## Almonry Development Working Group

Notes from a videoconference on 22 July 2020

### Other toilet provision

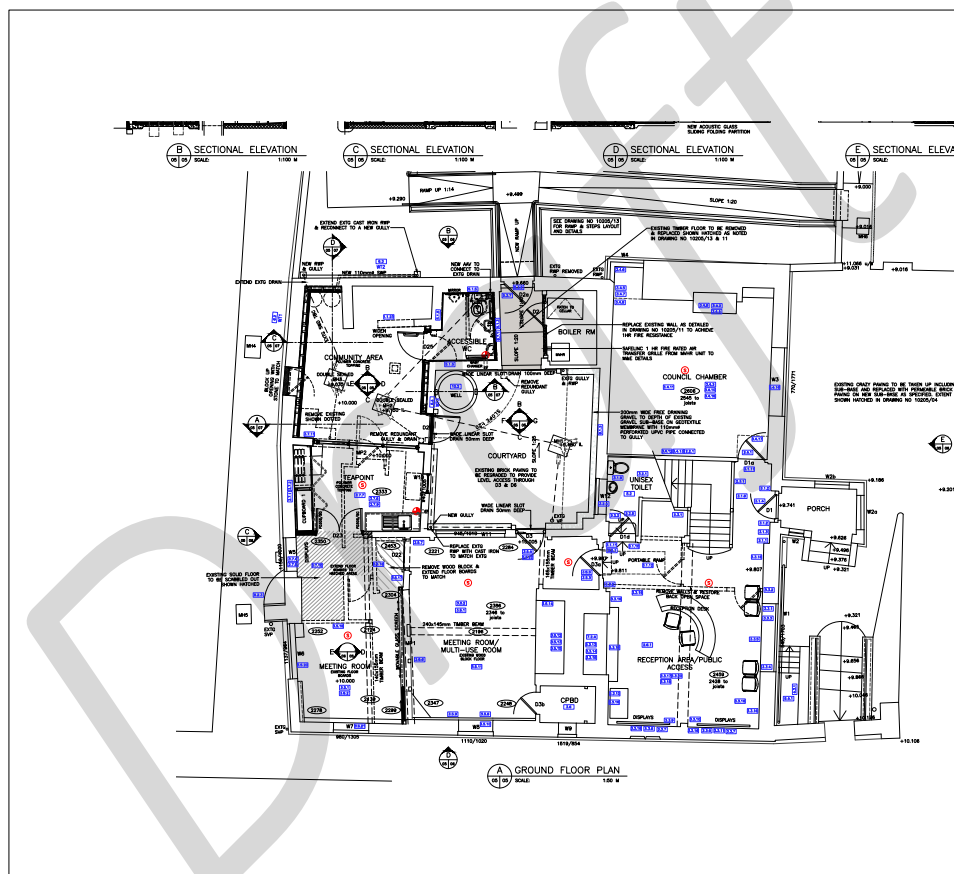
In order to ensure adequate provision for when the site is being used to capacity, it had been agreed that the Working Group would recommend to Council that the outside toilet is given a face-lift to provide two basic WC cubicles. This facility would then also be available for the use of visitors to the garden and the Museum. However, SG now believes that the three toilets (two on the ground floor and one on the first floor) should be sufficient. Council may decide to undertake a basic face-lift of the outside toilet within the current works or leave it for a later phase.

## Ramped approach from front garden to existing entrance

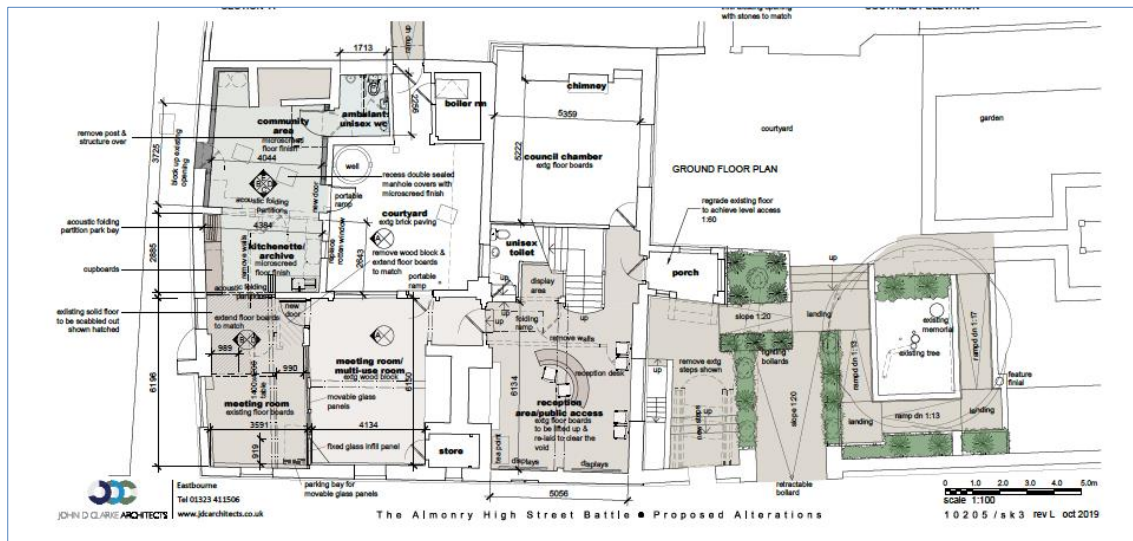
This design was rejected by Council in 2019.

## Ramped approach for High Street Gate to existing entrance

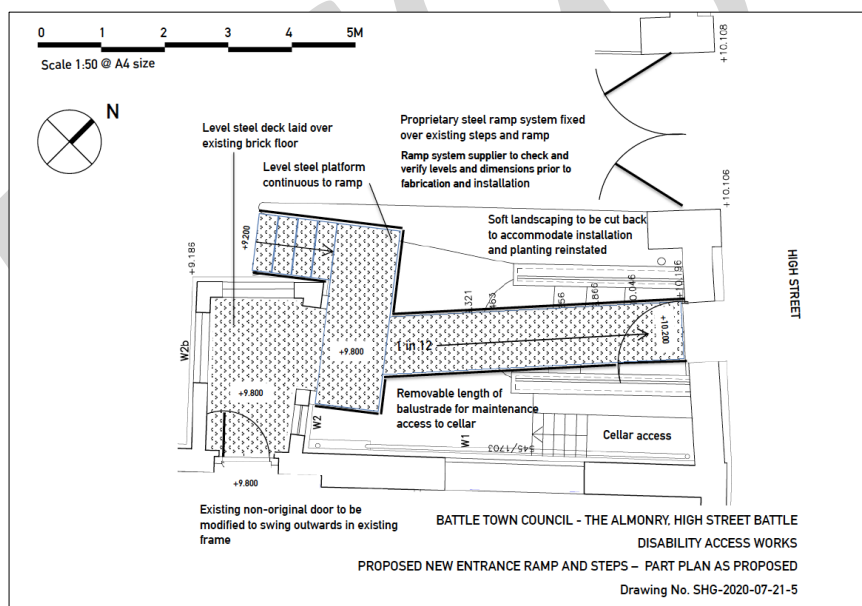
The 1 in 12 ramp is just acceptable. Visitors needing level access will need to go back to the High Street and use the driveway to access the Museum from The Almonry. Visitors unable to negotiate a slope will not have stepped access from the High Street, although there are steps from The Almonry to the sloping driveway.

## Platform lift behind porch

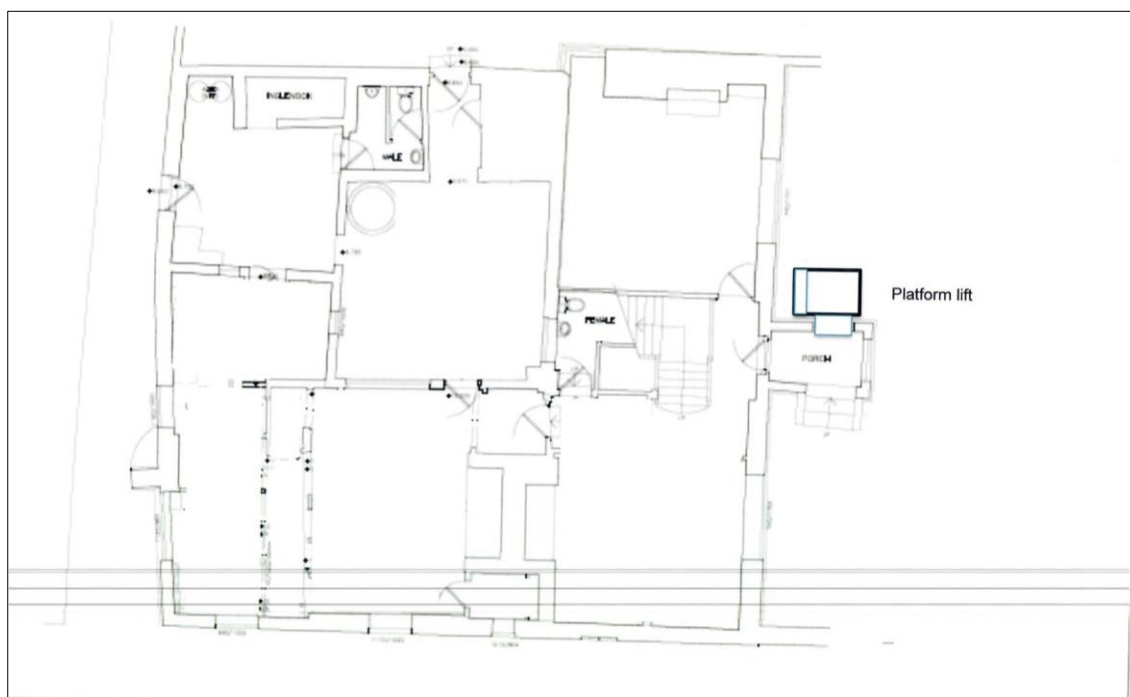
This solution had previously been discounted as unfeasible, partly due to the surface and steepness of the driveway from the High Street. However, SG will draw up a plan to raise the level of the porch floor, re-hang the main door to open outwards and install an enclosed lift.

The removal of the partition in the hall by the stairs, as in the plans that have already received Listed Building consent, would not only give a feeling of space, but, more importantly, add light for visually impaired people.

The Working Group recommends the lift option to Council.
